Re: Second Submission Review – Green Valley Ranch East Site Plan No. 15 - Site Plan and Plat

Application Number: **DA-1662-26**

Case Number(s): 2022-4014-00; 2022-3019-00

GREEN VALLEY RANCH EAST SITE PLAN #15

TYPICAL PORCHLIGHT POD SETBACKS AND EASEMENTS

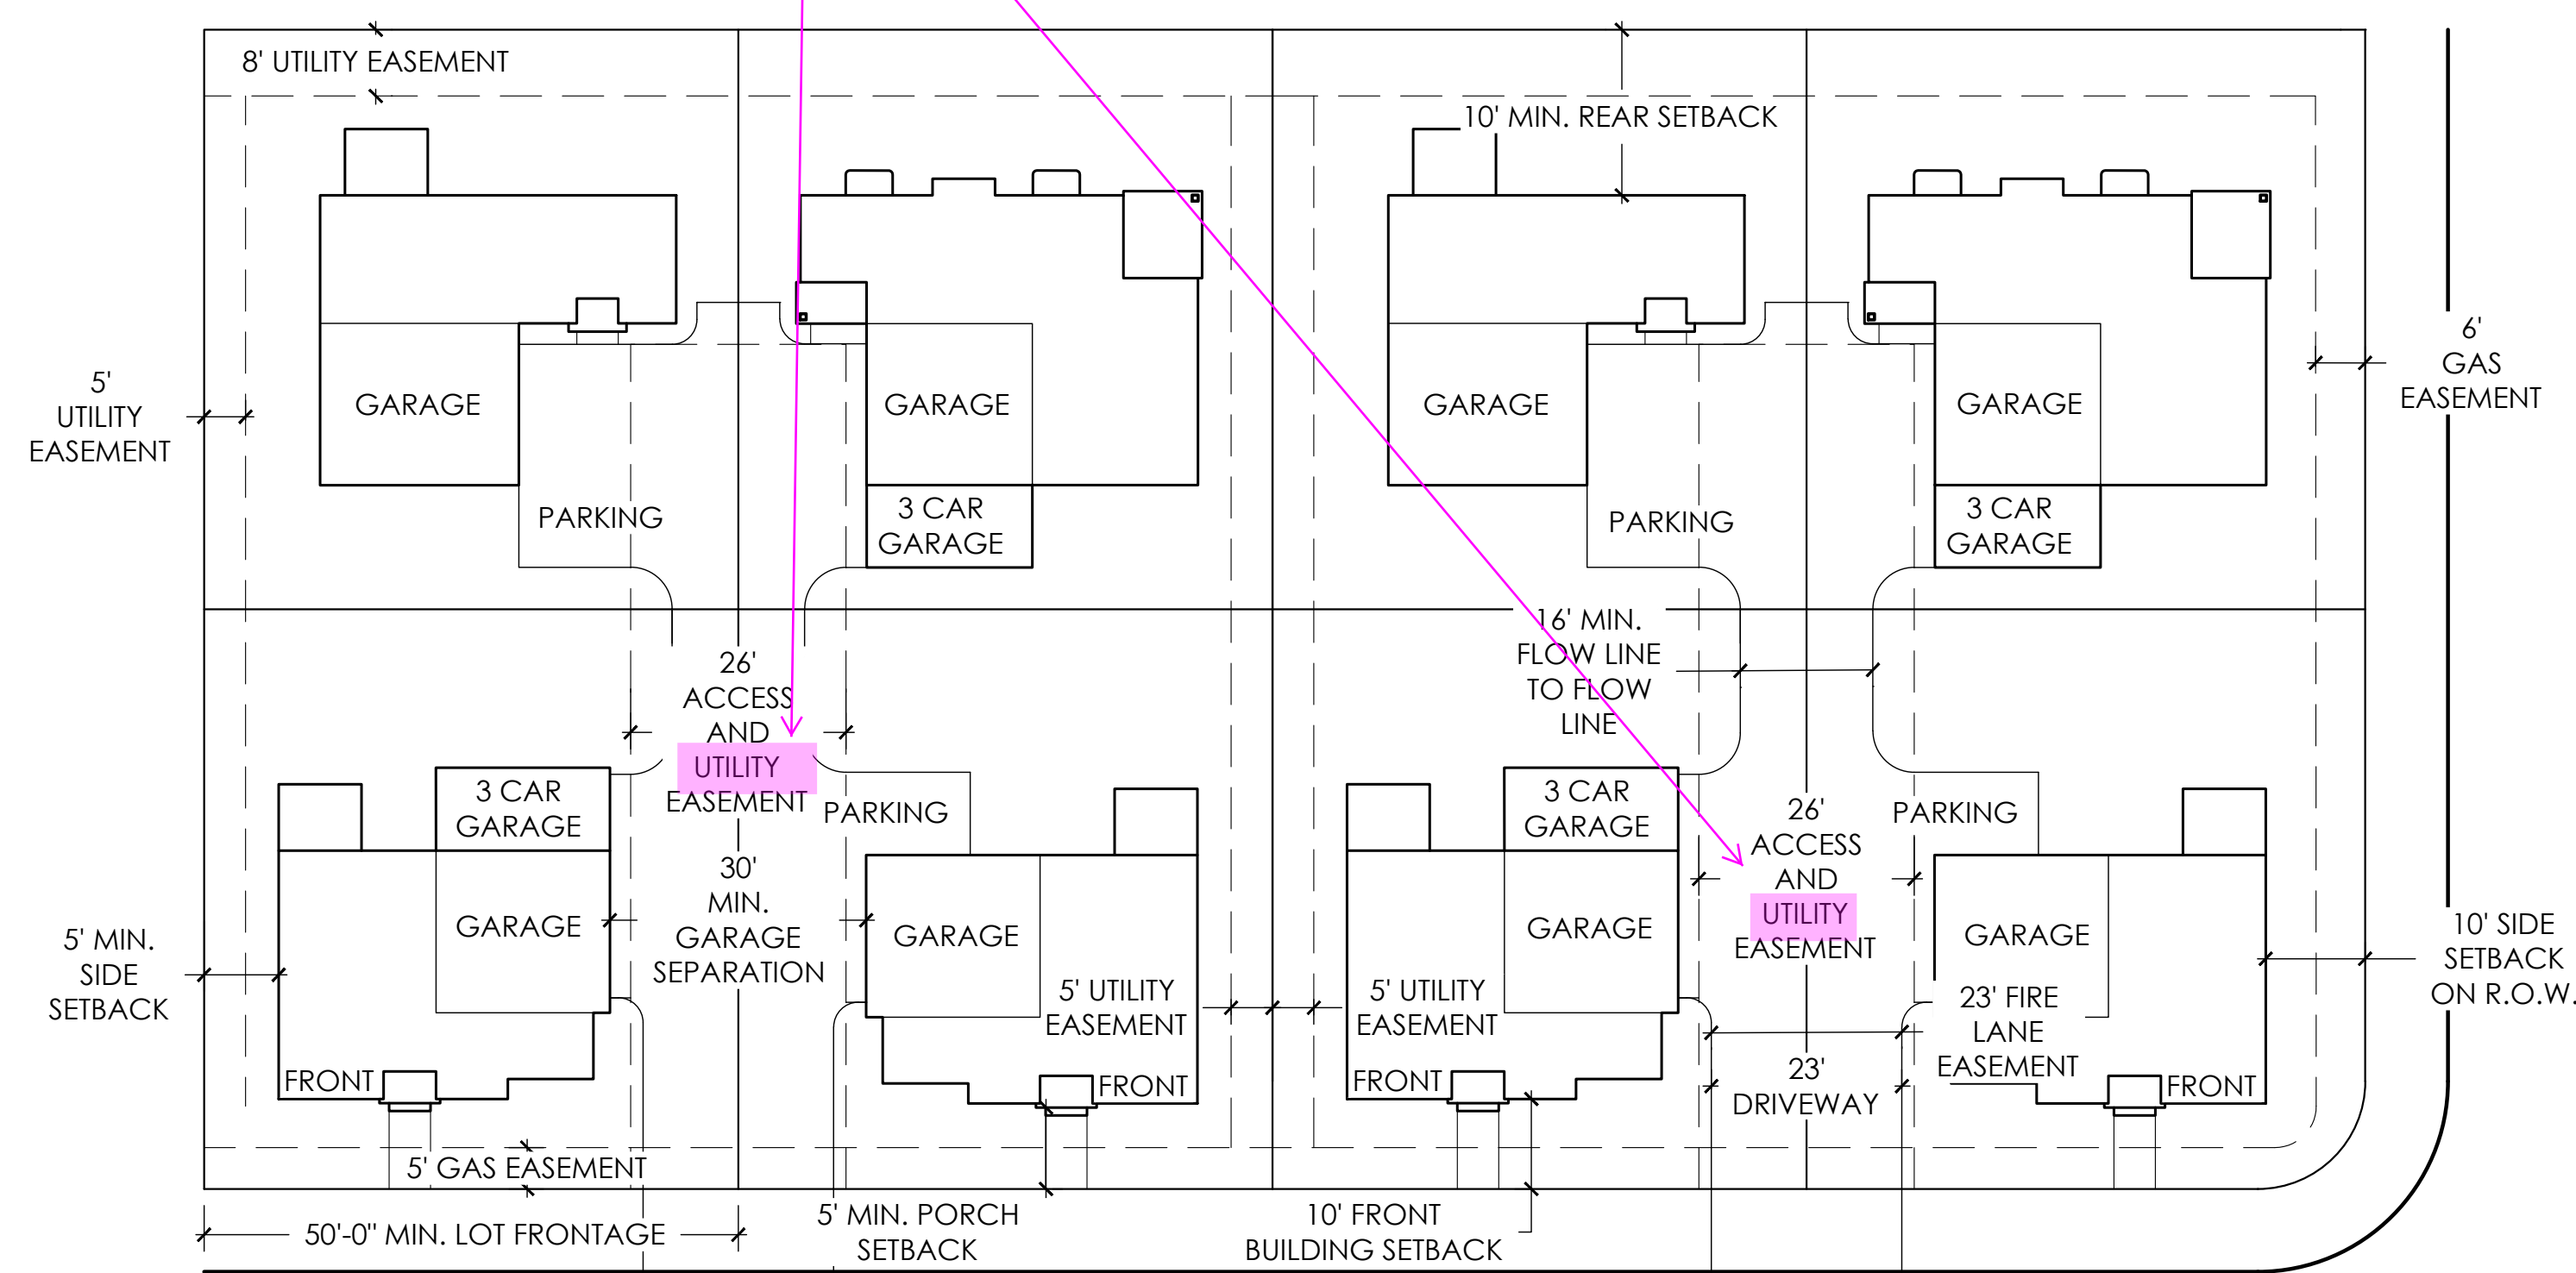
Add a note that the paver shall be owned and maintained by the Metro District including the pavers outside of the easements.

SITE PLAN

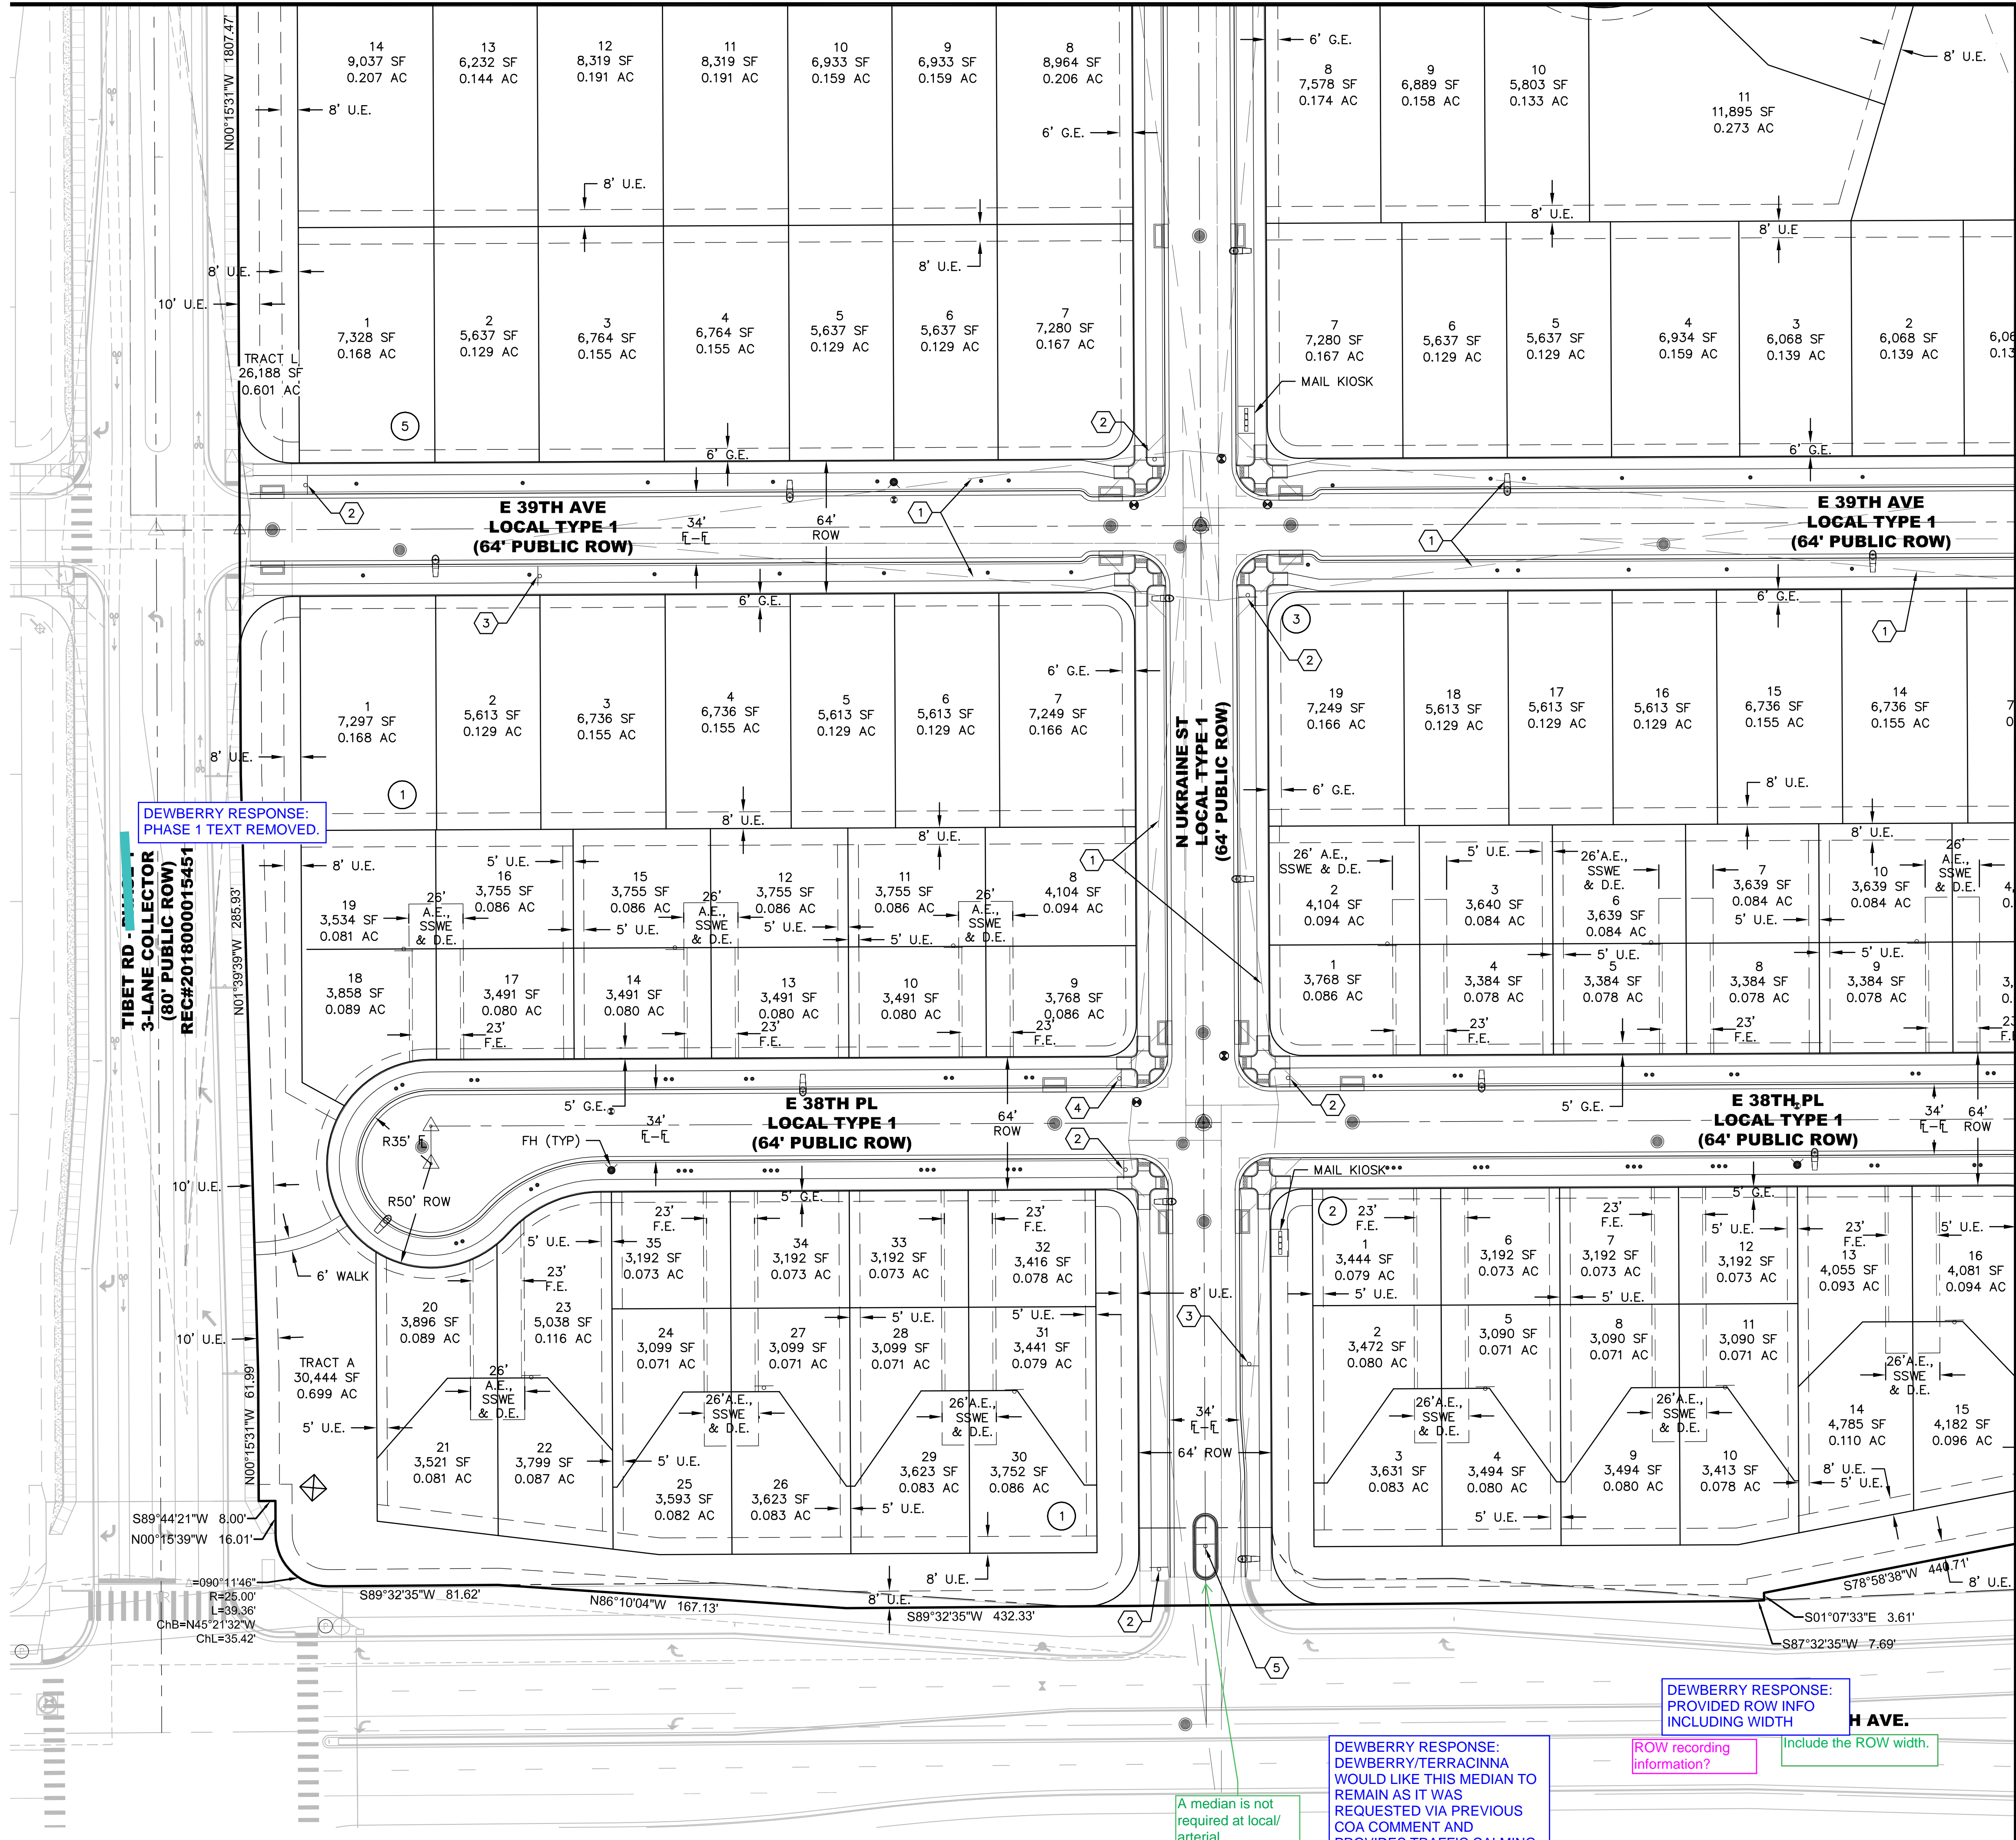
6H. Sheet 10: Is this the correct symbol. **RESPONSE: Revised to correct symbol**

Is this the correct symbol?

DEWBERRY RESPONSE: REVISED TO CORRECT SYMBOL

**N. VERSAILLES CT
LOCAL TYPE 1**

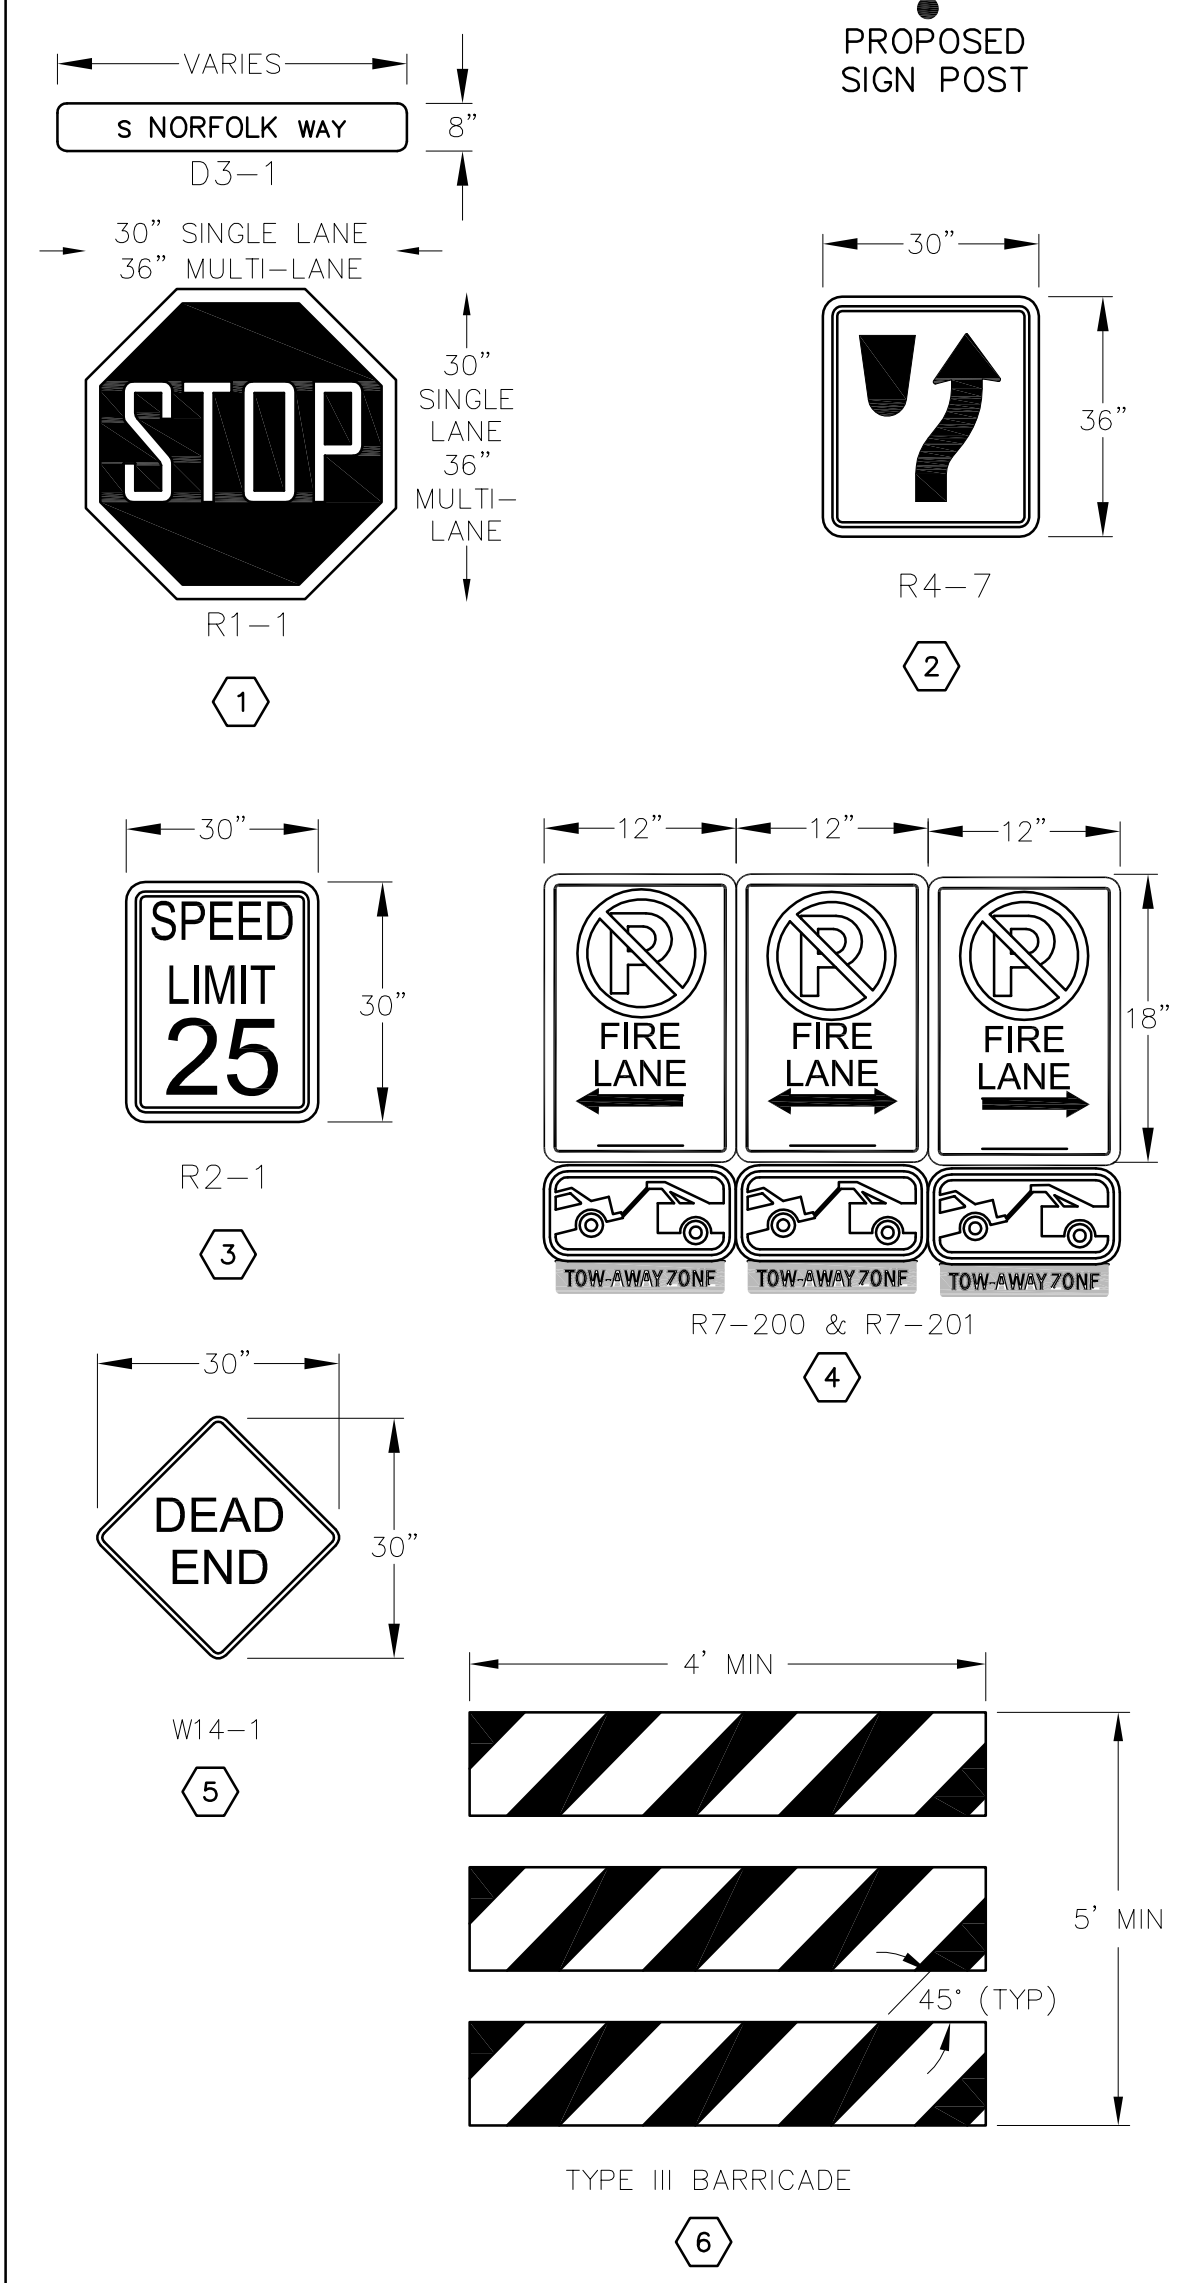
8B. Sheet 18: The four pack unit fire lanes need an additional fire lane sign. Add a fire lane sign at the entrance of the fire lanes. **RESPONSE: Additional fire lane signs have been added**

The four pack unit fire lanes need an additional fire lane sign. Add a fire lane sign at the entrance of the fire lanes.
